Re: FCC ID MIJMILHUB-USA-01
Applicant: Motorola GSTG
Correspondence Reference Number: 11114
731 Confirmation Number: EA95370
Date of Original E-Mail: 12/20/1999
Date of Response: 1/21/2000

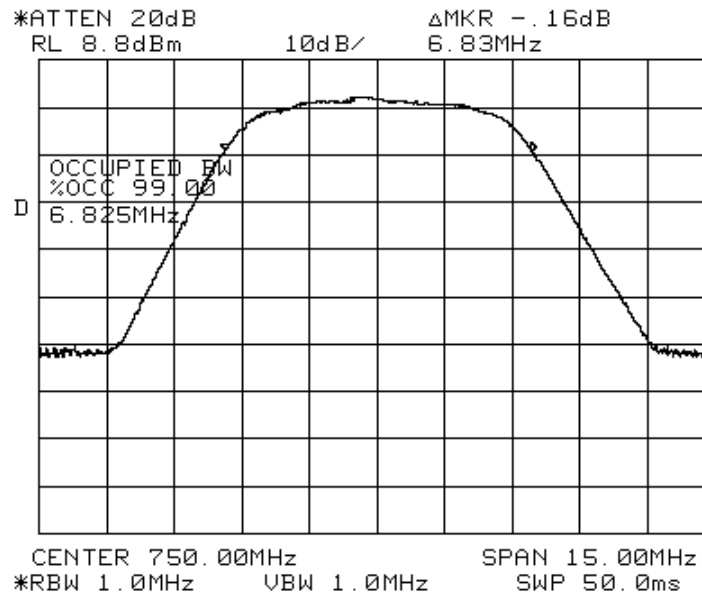
- 1.) *Please show the highest and lowest operating frequency that will satisfy the emissions limitations / mask.*

The frequencies that are to be used by the Millitech Band A HUB's are as follows:

- 28.143 GHz Data
- 28.155 GHz Data
- 28.167 GHz Data
- 27.644 GHz Pilot

These HUB's were built for a specific site installation and are not to be used at any other locations or with any other frequencies of operations. None of the listed frequencies are near the edges of the allocated band (27.500 and 28.350 GHz).

Data - Occupied bandwidth measured with a 1 MHz resolution bandwidth.

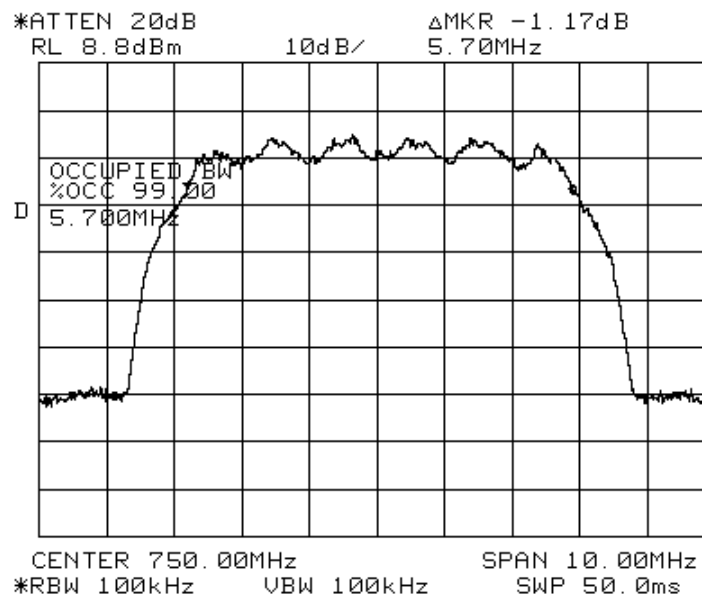
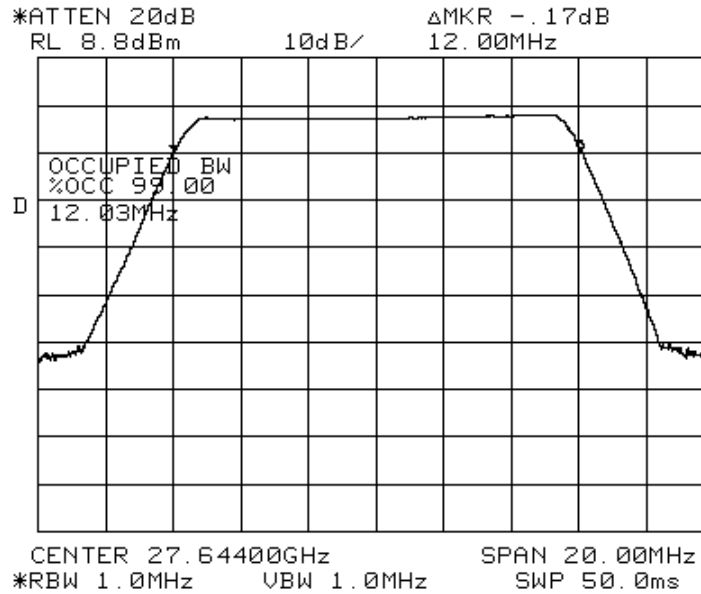
- 2.) *Please provide a determination of necessary or occupied bandwidth.*

The necessary or occupied bandwidth for the HUB is determined by the Data over Cable Interface System Specification (DOCSIS). The modulation used for the router end is 64QUAM at a symbol rate of 5.0MS/s with a filter alpha of 0.15. The following graphs are the measured occupied bandwidth at the output of the signal generator used to supply the IF input to the HUB measured with a 1 MHz and a 100 kHz resolution bandwidth. Because the HUB is simply a frequency translator the occupied bandwidth at the HUB's transmit frequency will be identical.

Data - Occupied bandwidth measured with a 100 kHz resolution bandwidth.
